Response to Comment Letter 191

Jeffrey and Laura McKernan March 3, 2014

7345 Final PEIR 191-1

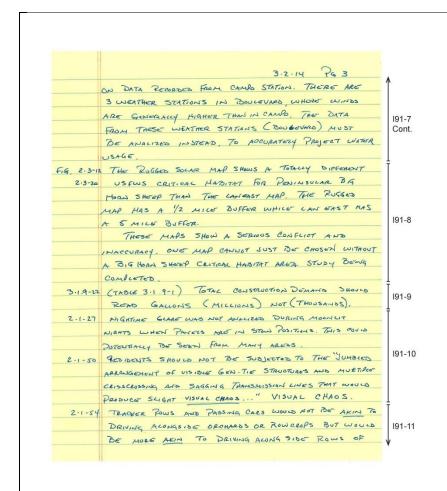
3.2.14 Poz
1.0-7	THE NORMAL OPERATING TEMPATURE FOR THE SOLAR
1.0-8	MODULES WILL BE 1720 IN THE SUMMOR, AND 1040
	IN THE WATER. THE UNDERGROUND COLLECTION SYSTEM
	WILL ALSO GENERATE SURFACE HEAT, WHEN ALL THE
	NATINE VELLETATION IS REMOVED, THE SURFACE TEMPERATURE
	WILL INCREASE. THIS WILL BE A SUBSTANTIAL INCREASE
	IN SURFACE TEMPERATURE.
	THE CPV MODULAR DENSITY ALONG, IS EQUAL
	TO 48 WALMART SUPERCENTERS. THIS WOULD NOVER
	BE ALLOWED ANYWHERE IN THE COUNTY, IN ONE
	TOWN OR COMPONITY.
	THE POSSIBLE EFFEETS OF INDREASING SURFACE
	TEMPERATURE BY THIS MUCH, IN SUCH A LARGE AREA
	SHOULD BE ANALIZED . MA MANAGERE THESE PROJECTS
	NEEDS TO BE IN COMPLIANCE WITH POLICY COS-14.12
	(HEAT ISLAND EFFECT).

1.0-30	IF " M A PERFECT SCENARIO", REFLECTIONS WOULD BOUNCE
	BACK (DIRECTLY) TO THE SUN, WHAT PERCENTAGE OF
	oferation is considered A PERFECT SCONERIO, AND WHAT
	ARE THE RESULTS OF AN IMPERFECT SCENAR.O. THERE IS
	DOCUMENTATION OF PRODUCTIONS AT SOITERS NEW BERRY
	SPRINGS 1.5 MW FACILITY. THE PROPOSED PROJECTS DWARF
	THAT SITE.
	DOULEVARD AND IT'S RESIDENTS SHOULD NOT BE AN
	EXPERIMENT.

1.0-42	(TABLE 1-6) DUST JUPPRESSION IS DASED ON 22
	DAYS OF WINDS HIGHER THAN IS MPH, AND IS BASED

San Diego County General Plan Policy COS-14.12, **I91-5** Heat Island Effect, states: "Require that development be located and designed to minimize the "heat island" effect as appropriate to the location and density of development, incorporating such elements as cool roofs, cool pavements, and strategically placed shade trees" (County of San Diego 2011). The trackers are lightweight and surrounded by airflow both inside and outside the tracker. As a result, heat dissipates quickly from a tracker. As described in Chapter 1.0, Project Description, of the DPEIR, the normal operating temperature for solar modules is 20 degrees Celsius (°C; 52 degrees Fahrenheit (°F)) above ambient temperature; therefore, on a typical summer day at 40°C (104°F), the panel temperature would be

approximately 60°C (172°F). When accounting for irradiance (a measure of solar radiation energy received on a given surface area in a given time), wind, and tracker type, it is expected that the peak tracker temperatures in the summer would be between 65°C and 70°C (149°F and 158°F), and the peak tracker temperatures in the winter would be between 35°C and 40°C (95°F and 104°F).

Although the trackers would be hot to the touch as a result of solar energy absorption, trackers are designed to absorb light energy inwards towards the tracker to produce electricity. As opposed to mirrors, which redirect the sun, trackers use Fresnel lenses to concentrate sunlight inside the module to produce electricity; therefore, they would not noticeably affect the temperature of the surrounding area. Temperatures below the trackers would be nearly the same as ambient temperatures in ordinary shade. Ultimately, although the trackers do create heat due to dissipation of the heat in the trackers, they also create shade. The heat generated from the trackers is natural; without the presence of the trackers the heat would still be present, but less localized, and all the solar irradiance would be dissipated into heat in the environment. Therefore, the trackers are not anticipated to cause a rise in temperatures at the site above what would otherwise occur without the Proposed Project, or produce a heat island effect.

The statement the commenter is referring to is intended to clarify how the technology works during the tracking procedure, in which the tracker will remain in position directly perpendicular to the sun's rays. This period occurs after the wake procedure (sunrise) and before the sleep procedure (sunset) as described in Section 1.2.2.1 of the DPEIR. The reflections and glare are analyzed in detail in Appendix 2.1-3 of the DPEIR. While in a perfect scenario reflections will bounce directly back to the sun, the analysis provided in Appendix 2.1-3 accounts for slight deviations in panel tracking movement and surface light scattering by allowing for a one degree light spread from the face of the panel.

The commenter does not provide details or documentation regarding problems at Newberry Springs facility or how that relates to the analysis of the Proposed Project in the DPEIR; therefore, no further response is provided.

See response I25-2 and common response WR-1, Table 1 regarding wind data used to analyze water demands. See response to comment I27-2 for further information regarding the analysis of fugitive dust and project design features implemented as part of the Proposed Project to minimize fugitive dust.

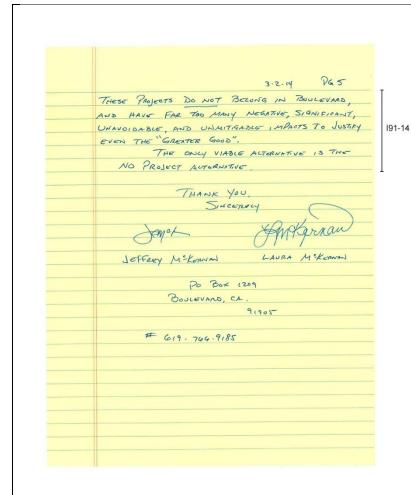
3.2.14 Pa4	
	BOXCARS (TRAIN), OR SEMI-TRUCK TRAILORS.	^
	TRACKERS ARE MAN MADE AND "NO WAY RESEMBLE	I91-1
	ABRICULTURE.	Cont.
2.1-70	RENEWABLE ENERGY DEVELOPMENT IN THE STUDY AREA	Ī
	WOULD RESULT IN THE "INTRODUCTION OF NUMBEROUS	
	AND PROMINENT INDUSTRIAL ELEMENTS "

2.1-71	" THE SHEER VOLUME OF WIND TURBINES, TRACKERS	
	GEN TIE LINES, ANCILLARY FACILITIES, REFLECTIVE SURFACES,	
	AND MECHANICAL MOVING COMPONENTS WOULD OBSTRUCT,	191-1
	INTERRUPT AND DETRACT"

2.1-72	"ONCE CONSTRUCTED THOSE PROJECTS WOULD ALTOR	
	THE EXISTING PURAL CHARACTER AND WOULD INCREASE	
	THE PROMINERCE OF INDUSTRIAL COMPONENTS"	
	". AS VIEW SHED BECOMES INCREASINGLY INDUSTRIAL	
	AND DECREASINGLY RURAL"	
		T
	THIS DPEIR IS NOT IN COMPLIANCE WITH THE	
	S.D. CO. GENERAL PLAN POLICIES:	
0		
2	20-6-1 (1) 20-11-11	
3	LU -6.6 (12) COS- 11.1	
9	cu - 6.9 (3) cos. 11.3	191-1

(3)	LU -6.10 (14) Cos-11.7	
6	LU - 6.11 (15) POS-12.2	
9	20 - 10.2 (16) COS- 14:12	
8	LU-10.4 (17) cos-19.1	
(9)	40-8.3

The characterization of the proposed gen-tie line as a "jumbled arrangement" is presented in Section 2.1.3.2 of the DPEIR. The County acknowledges the commenter's opposition to the project. The information in this comment will be in the Final EIR for review and consideration by the decision makers.

- 191-11 The analogy to row crops and orchard rows was intended to reference the repetition of rows in the landscape and the perception of these features drivers have while moving through the landscape. While trackers are manmade features, the visual experience of driving past them would be similar to that of passing by repeating rows of equally spaced features in the landscape, such as row crops or orchards. The comparison was not intended to equate these features in any other terms.
- **I91-12** The comment consists of excerpts from Section 2.1, Aesthetics, of the DPEIR. Because the comment does not address the adequacy of the DPEIR, no further response is provided.

I91-13 The County disagrees with the commenter's assertion that the Proposed Project is not in compliance with the listed General Plan policies. County staff's rationale for reaching a conclusion of compliance with applicable General Plan policies can be found in Appendices 2.5-1 and 2.5-2 of the DPEIR. As the comment does not provide any specific information on the Proposed Project's alleged noncompliance with these policies, no further response can be provided.
